Traffic and Transportation

In accordance with the MEPA Scope, this chapter directly responds to agency and public review comments within MEPA jurisdiction. Copies of the Secretary's Certificate on the Draft Environmental Impact Report (DEIR) and each comment letter received during the public review period of the DEIR are included in this chapter. This chapter provides responses to those letters.

Table 6-2 Response to Comments

Figure 4.3f
Site Details - South Meadow Brook Park

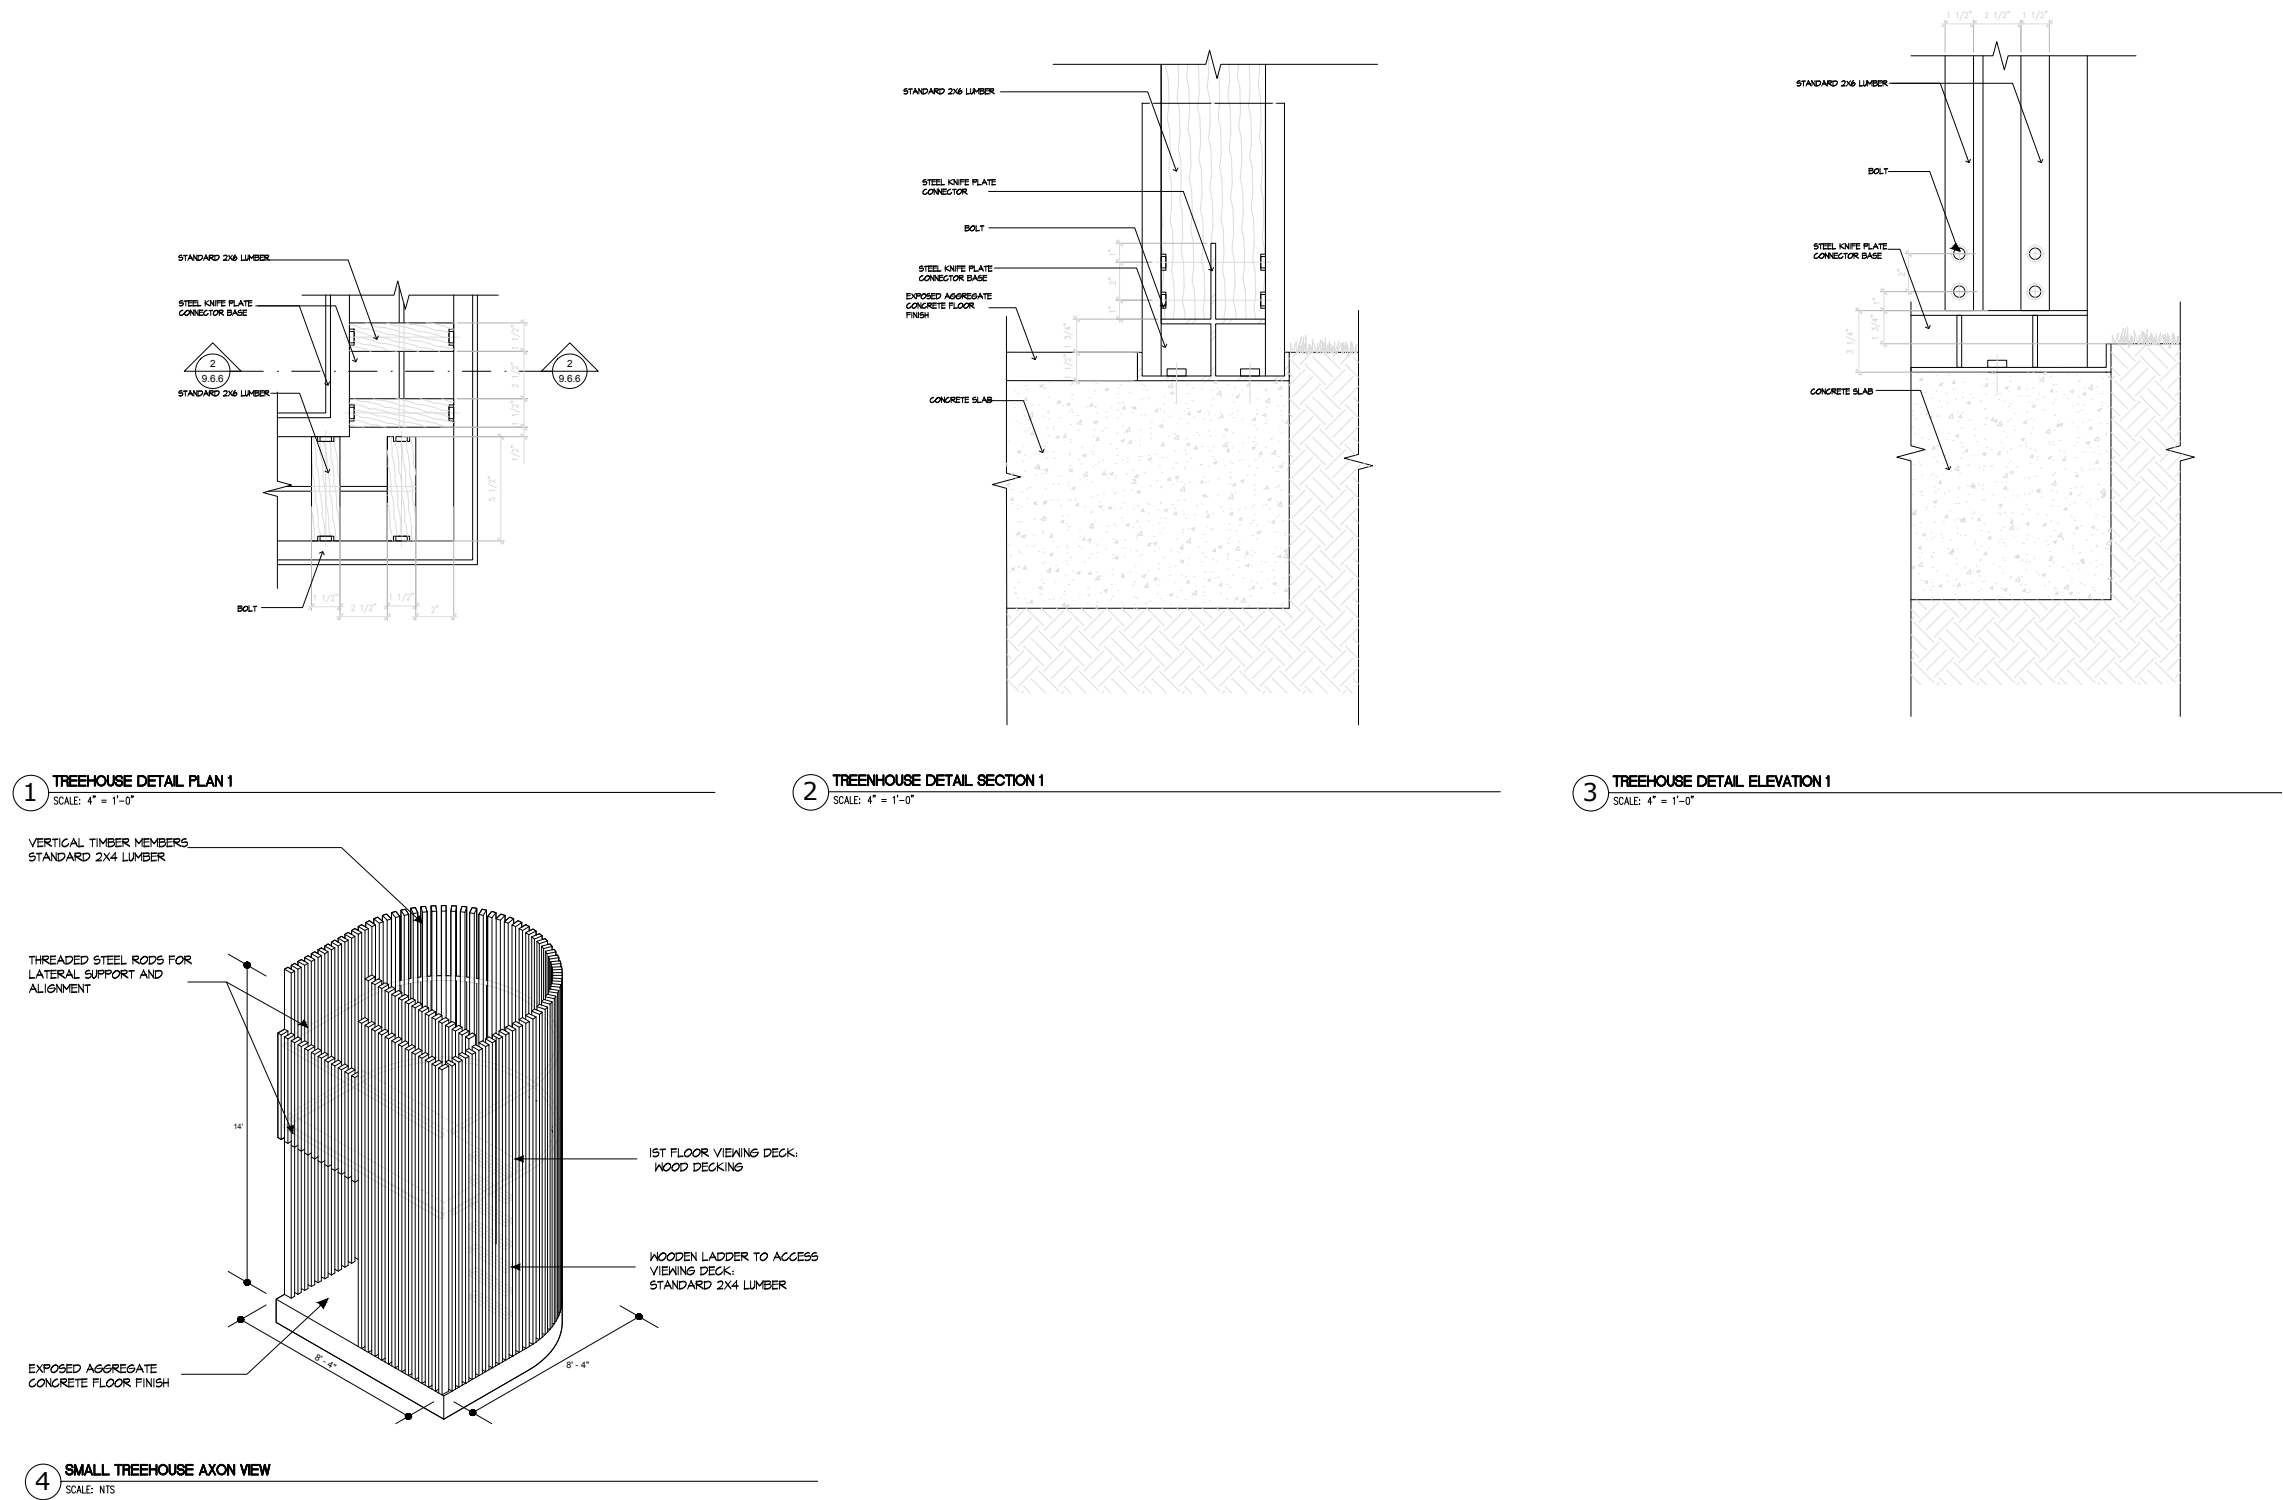
1.35	The FEIR should provide a plan clearly showing all project components within the Riverfront Area, quantify potential impacts to all wetland resource areas and floodplain and describe mitigation measures.	Figures 4.1 - 4.4h provide information on the plantings proposed for the Project and work within the existing daylighted section of South Meadow Brook. No work is proposed within Land Under Waterbodies and Waterways. Refer to Section 4.1 of Chapter 4, <i>Wetlands</i> for more details.

Comment #	Commenter	Comment	Response
5.04 CRWA	<p>Finally, given that the project includes work proposed in the 200 ft. Riverfront Area (RA) of the daylighted section of the South Meadow Brook, the FEIR should contain more details regarding the nature of the work. While the Proponent has committed to improving the RA by reducing the area of pavement and by planting a diverse selection of native trees, shrubs, and other plants, the FEIR should include a much more comprehensive stream restoration plan and supporting details.</p>		<p>Section 4.1 of Chapter 4, <i>Wetlands</i> includes a description the restoration of elements of the South Meadow Brook Riverfront Area. Figures 4.1 - 4.4h provide information on the plantings proposed for the Project and work within the existing daylighted section of South Meadow Brook.</p>
